TOLEDO - LUCAS COUNTY PLAN COMMISSIONS

REF: PUD-8009-22

SUBJECT: Planned Unit Development for multi-family development at 1338 N. Summit

ELEVATIONS - BUILDINGS 1-6

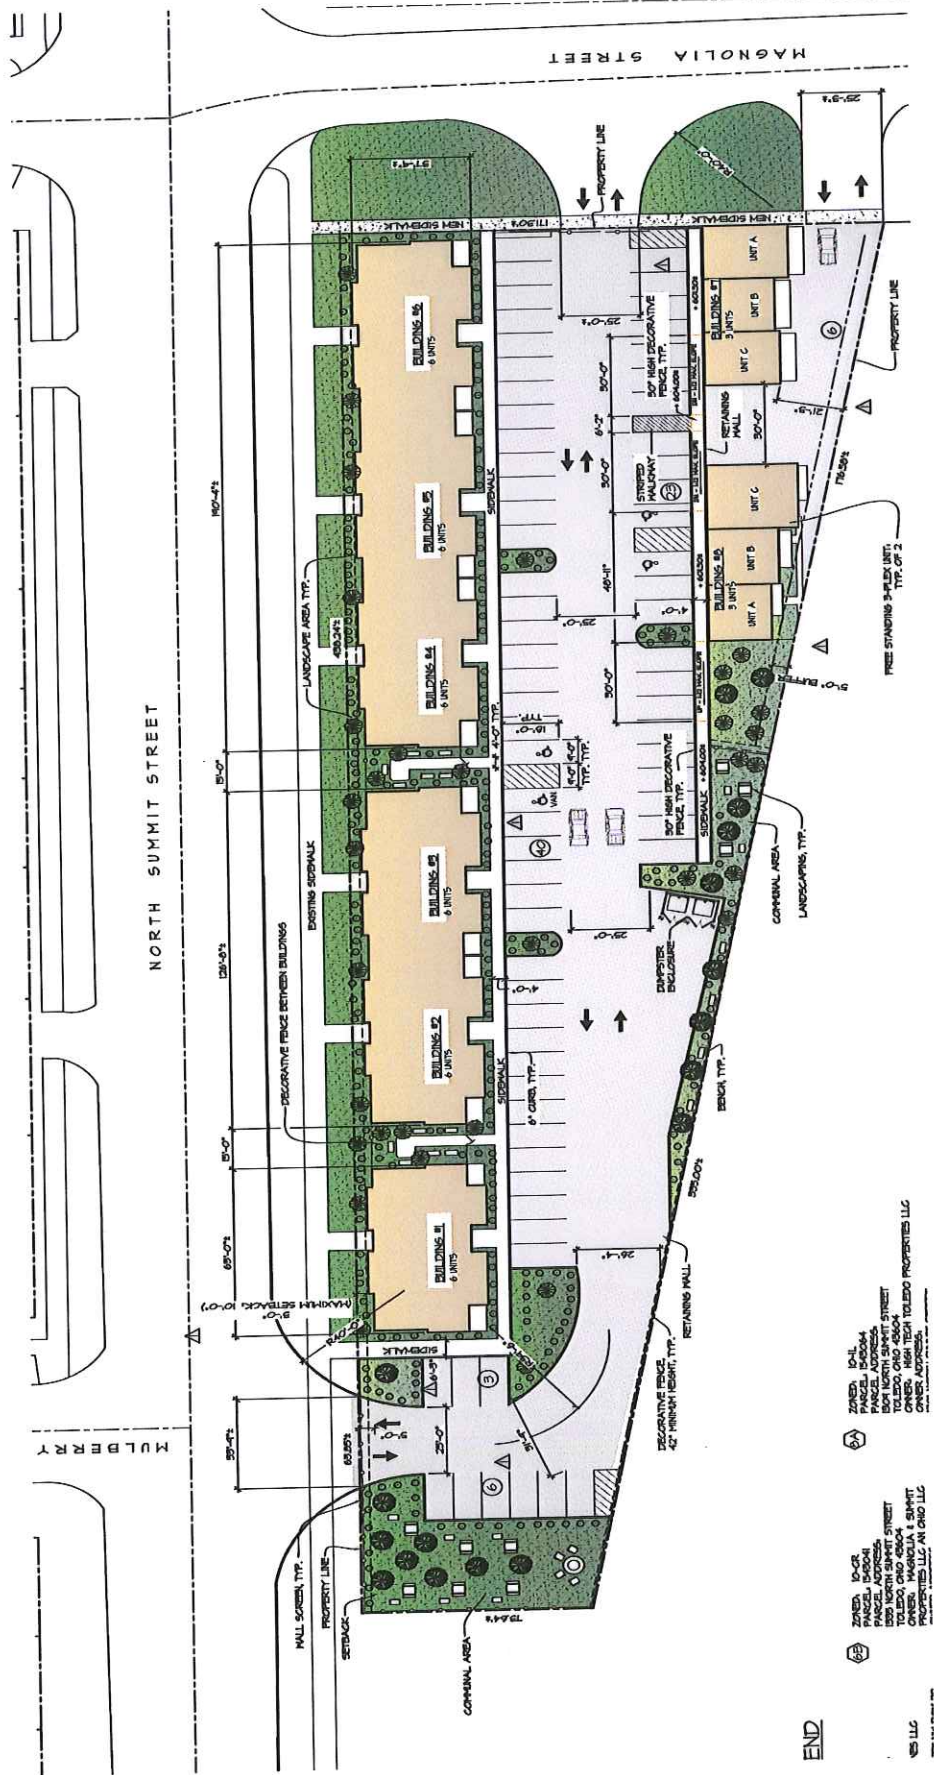
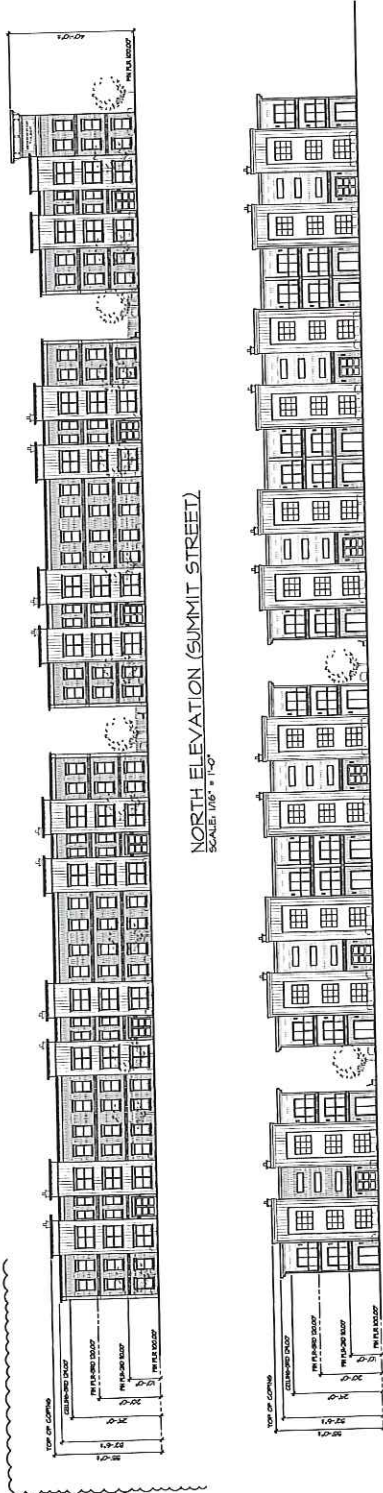
52. The elevations of buildings one through six (three-story buildings) are subject to TMC§1109.0500 Building Façade Materials and Color.
- a. North Elevations depict 37% Brick, 20% Composite Plank, 16% architectural metal, 27% Fenestration. **Acceptable as depicted**

- b. East and West elevations depict 62% Brick, 8% Composite Plank, 13% Architectural Metal, 17% Fenestration. **Acceptable as depicted.**
 - c. South elevations depict 26% Brick, 22% Composite Plank, 22% Architectural Metal, 30% Fenestration. **Composite plank shall be reduced below 20% or a waiver shall be obtained.**

Approve a waiver to not require eighty percent (80%) predominant materials along the southern façade, and allow for the use of twenty-two percent (22%) composite on the southern elevation. The applicant and architect have worked with staff to create a visually appealing design which satisfactorily meets the intent of the Zoning Code.

ELEVATIONS - BUILDINGS 7 & 8

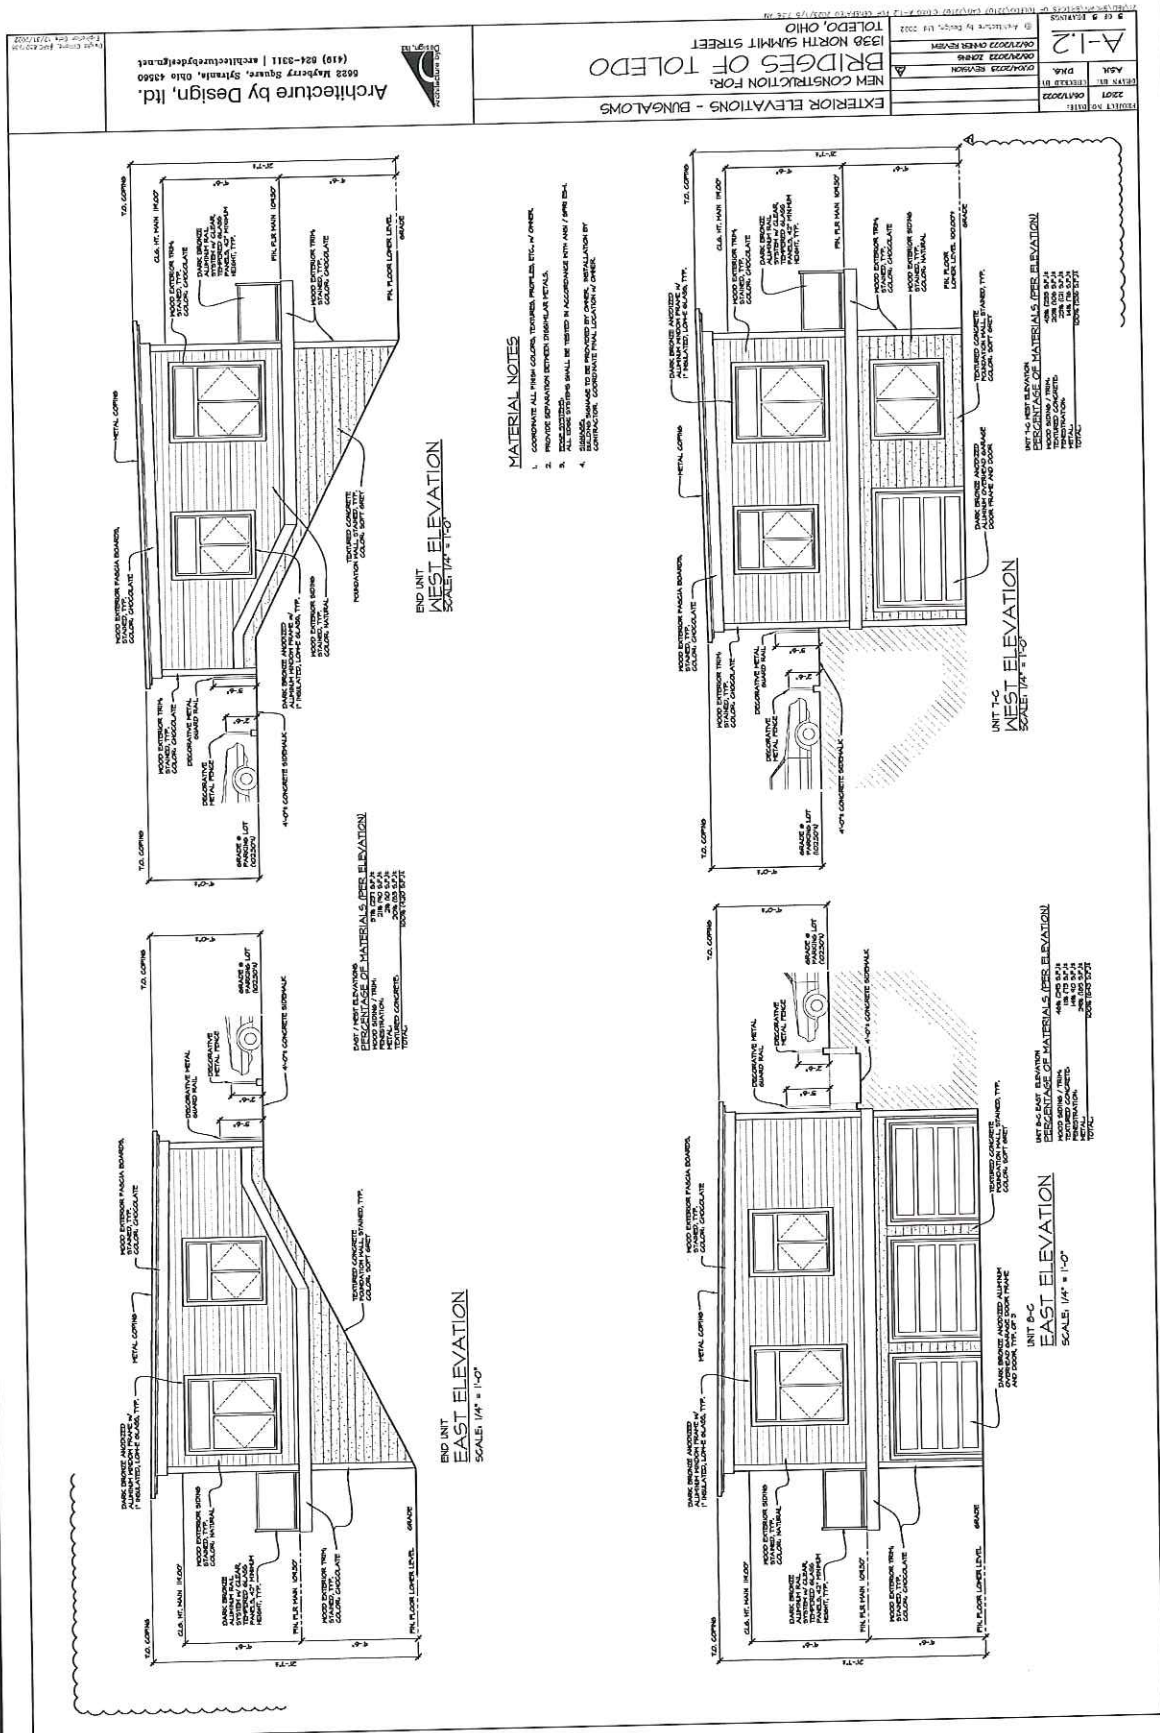
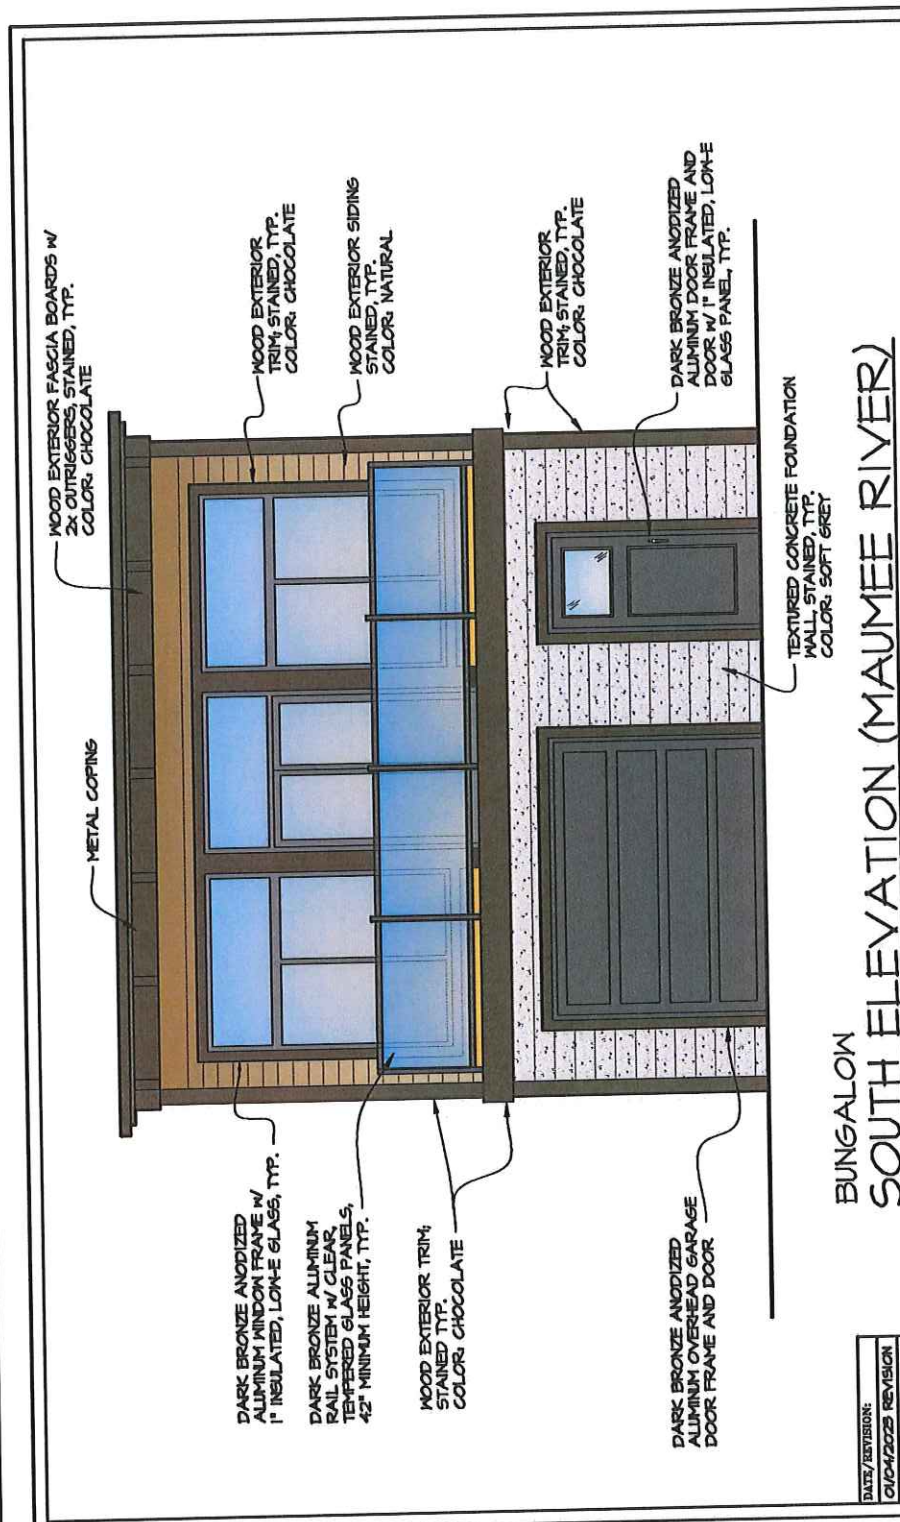
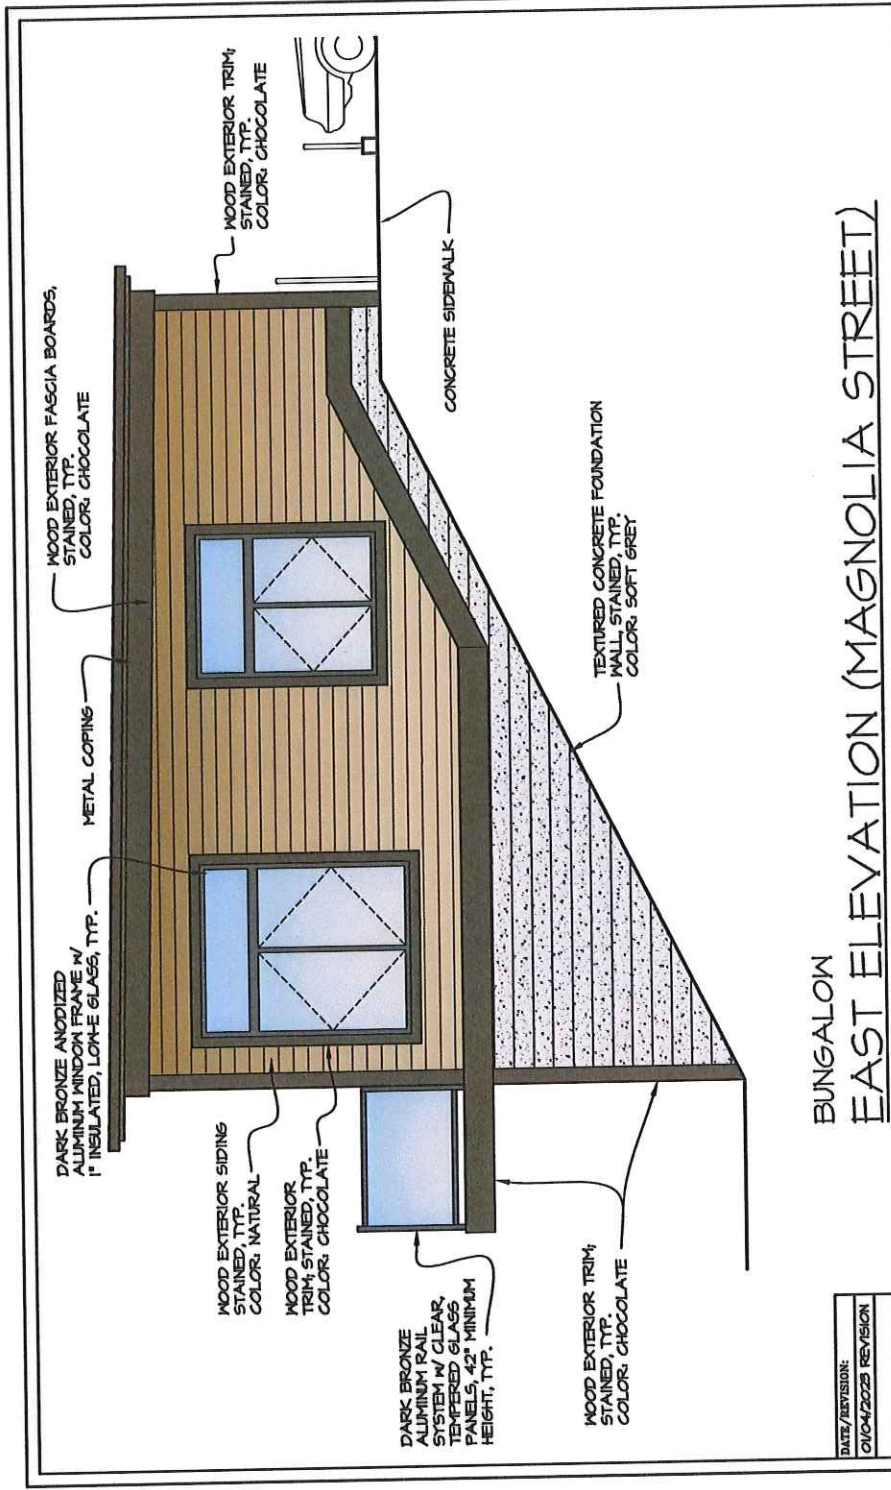
54. Units in buildings seven and eight (Bungalows) which do not have access to a 25' drive aisle shall not be permitted to include a garage door. **Shall be depicted on revised elevations.**
